UNITED STATES PATENT AND TRADEMARK OFFICE

APPLICATION NO.	FILING DATE	FIRST NAMED INVENTOR	ATTORNEY DOCKET NO.	CONFIRMATION NO.
10/560,822	04/05/2006	Gerard Olivier	281470US2XPCT	8916
22850 7590 07/19/2010 OBLON, SPIVAK, MCCLELLAND MAIER & NEUSTADT, L.L.P. 1940 DUKE STREET ALEXANDRIA, VA 22314			EXAMINER KWON, ASHLEY M	
			ART UNIT	PAPER NUMBER
			1795	
			NOTIFICATION DATE	DELIVERY MODE
			07/19/2010	ELECTRONIC

Office Action Summary	Application No. 10/560,822	Applicant(s) OLIVIER ET AL.	
	Examiner ASHLEY KWON	Art Unit 1795

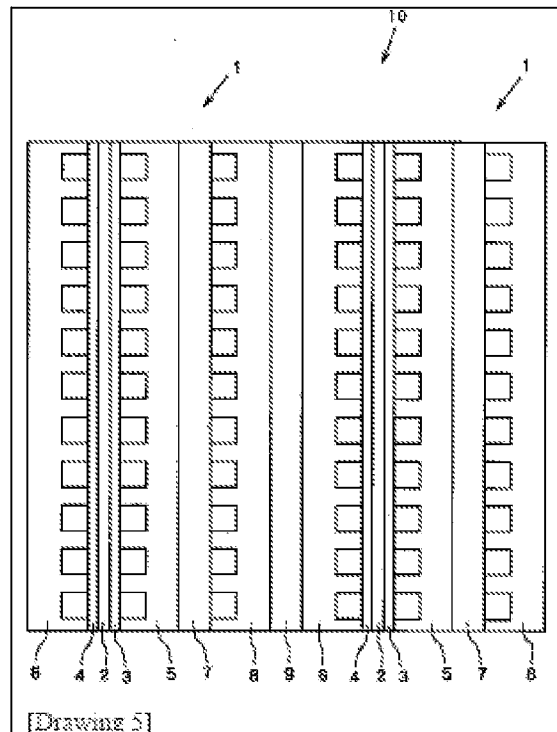
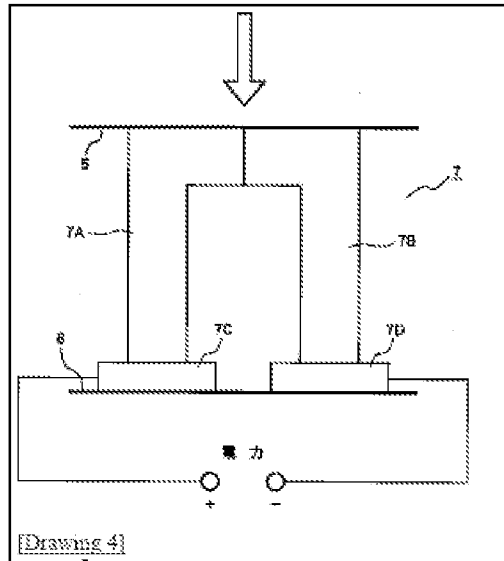
Regarding claim 10, Shirai discloses a fuel-cell stack (10), comprising: at least two adjacent elementary cells (1) capable of an exothermic combustion reaction constituting a heat source, the exothermic combustion reaction includes an oxidizer and a reactant, and the reactant and the oxidizer circulate within each elementary cell ([0008]-[0009]); an internal duct formed between the cells for circulation of a cooling fluid constituting a cold sink (field plate for cooling agent, 8); and a thermoelectric module (7, see drawing 4), each comprising a pair of elements of two conductive materials of dissimilar nature (p-type semi conductor 7A, n-type semiconductor 7B), a

first end of the pair being in thermal contact with one of the heat source (oxygen pole side field plate, 5) or the cold sink (field plate for cooling agent, 8), a second end of the pair being in contact with the other of the heat source or cold sink, and being electrically connected to a neighboring thermoelectric module (see drawing 5).

Regarding claim 11, Shirai in view of Yoshida disclose the fuel-cell stack according to claim 10, wherein the first end of the pair is connected with a conductive thermal contact to a bipolar plate of the heat source (*Shirai*: oxygen pole side field plate, 5), and the second end of the pair is in a thermal contact with the cold sink (*Shirai*: field plate for cooling agent, 8) (*Shirai*: see drawing 5).

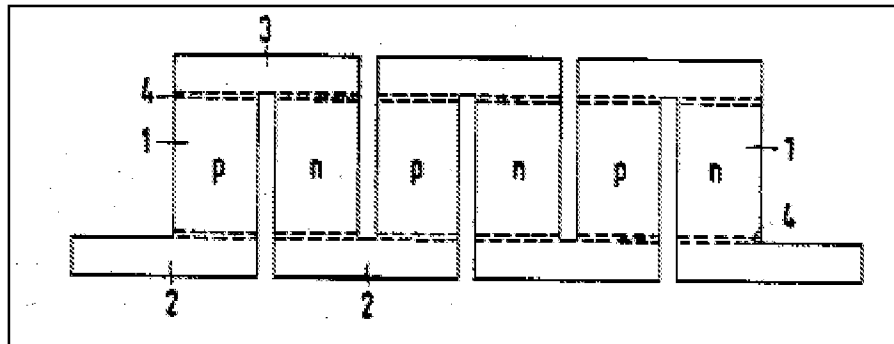
intended use, is within the ambit of one of ordinary skill in the art. See *In re Leshin*, 125 USPQ 416 (CCPA 1960) (see MPEP § 2144.07). A person of ordinary skill in the art would have found it obvious to use N-type materials that are alloys of silicon and germanium doped with phosphorus and P-type materials that are alloys of silicon and germanium doped with boron since silicon germanium alloys are well known to have high Z values, in order to improve the thermoelectric materials (see col. 4, lines 49-50).

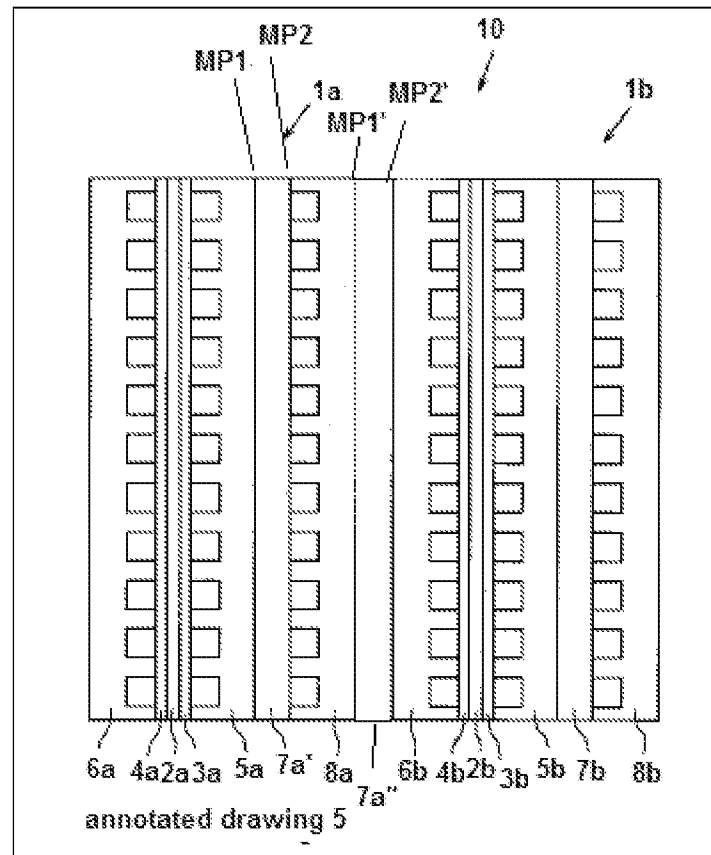
Regarding claim 19, Shirai in view of Yoshida discloses a fuel-cell stack (*Shirai*: 10), comprising: a plurality of fuel-cells electrically connected and configured to produce a first electrical power and heat from a reaction between an oxidizer and a reductant reactant (*Shirai*: [0008]-[0009]), the plurality of fuel-cells including a first fuel-cell (*Shirai*: 1b) and a second fuel-cell (*Shirai*: 1a); a first plate configured to transfer heat (*Yoshida*: 3, *annotated drawing* 5: MP1'); a first thermoelectric module layer (7a") configured to produce a second electrical power and the first thermoelectric module layer is disposed between and attached to the first plate and the first fuel-cell. For the purposes of this

rejection, all of the plates labeled as metal plates 3 by Yoshida (*annotated drawing 5: MP1'*) will be interpreted comprising said "first plate".

However, Shirai teaches that although the embodiment described contains a thermoelectric element adjacent to the oxygen pole side field plate, the thermoelectric element could also be placed on the opposite side adjacent to the fuel electrode side field plate. Heat generated with the oxygen electrode transmits to the fuel electrode so there is a rise in heat on the fuel electrode side as well ([0029]). Thus Shirai teaches that the thermoelectric element, which transforms thermal energy into electrical energy, can be combined with either the oxygen pole side field plate or the fuel electrode side field plate ([0035]). A rationale to support a conclusion that a claim would have been obvious is that all the claimed elements were known in the prior art and one skilled in the art could have combined the elements as claimed by known methods with no change in their respective functions, and the combination would have yielded nothing more than predictable results to one of ordinary skill in the art. See *KSR International Co. v. Teleflex Inc.*, 550 U.S. ___, ___, 82 USPQ2d 1385, 1395 (2007) (see MPEP §§ 2143 and 2143.02). Therefore it would have been obvious to one of ordinary skill in the art that a thermoelectric element could be placed on **both** the oxygen pole side field plate and the fuel electrode side field plate since it is known in the prior art for a thermoelectric element to be placed on either side. One skilled in the art would realize that by placing the thermoelectric element on both sides one would be able to more efficient convert the heat generated by the fuel cell into electrical energy since heat is gathered from the fuel and oxygen electrode sides. See annotated drawing 5 above.

Furthermore, Shirai teaches that when a fuel cell stacks consists of three or more fuel cells, a thermal break (9) is preferred between each generating cell. However, Examiner would like to point out that a preferred embodiment is not the only embodiment possible. One of ordinary skill in the art would realize that if a thermoelectric element is placed on **both** the oxygen pole side field plate and the fuel electrode side field plate, the thermal break (9) is unnecessary since one would want to gather heat from adjacent fuel cells in order to increase the temperature difference at opposite ends of the thermoelectric element (see annotated drawing 5).

Annotated drawing 5 above depicts a second plate (MP2) configured to transfer heat; a second thermoelectric module layer (7a') configured to produce a third electrical power and the second thermoelectric module layer is disposed between and attached to the second plate (MP2) and the second fuel-cell (1a); and an internal duct passageway (8a) configured to circulate cooling fluid and to bring the cooling fluid in contact with both the first plate (MP1') and the second plate (MP2), and the internal duct passageway is disposed between the first plate and the second plate.
